Nkula Falls hydro-electric scheme initial development

R. S. ARNOT, D. D. A. PIÉSOLD & J. G. WILTSHIRE

DISCUSSION

Fig. 17. Typical runner damage

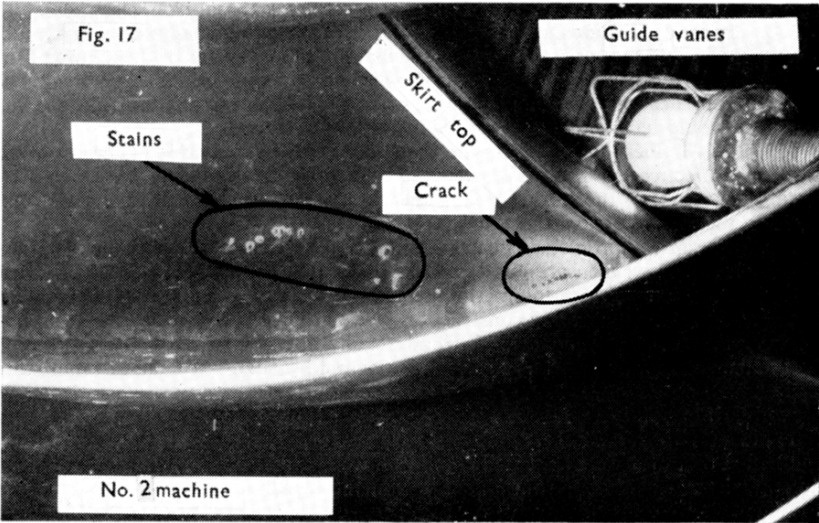
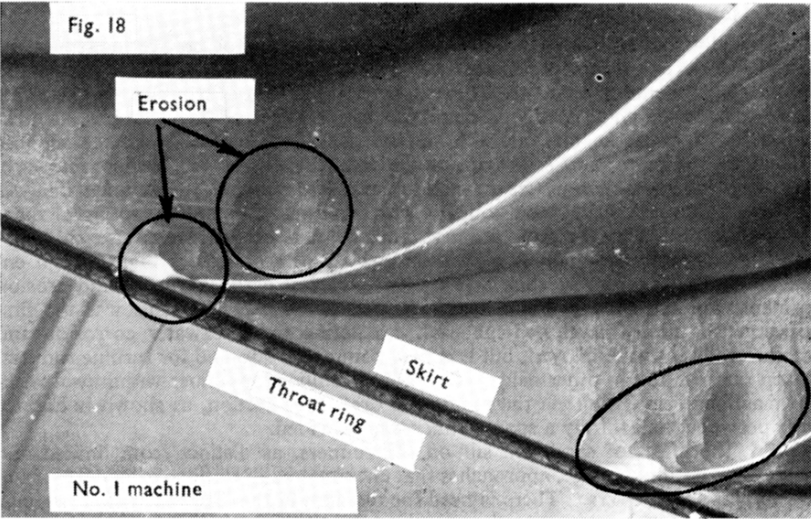
143. The effect of sand and silt on the runners, as distinct from limited and unusual cavitation damage, approaches that encountered in stations using water from glacial and alpine rivers. There is need for research in this field on basic materials, but three papers¹⁻³ on protective coatings to the International Association of Hydraulic Research Symposium in 1968 are potentially encouraging as inexpensive maintenance techniques.

144. Figs 17 and 18 illustrate the nature of the damage sustained by two runners after several thousand hours' operation; the effect of the sand and silt carried through the runner passages will be seen to resemble ripples on the bed of a river. Fig. 18 also shows pronounced blade edge thinning. This material has high erosion resistance; the damage gives some idea of the abrasive action of the river water. Figs 17 and 19 also reveal incipient cracking in the vicinity of the blade outlet cavitation at the blade inlet/crown junction, which is a rather unusual location for this type of damage.
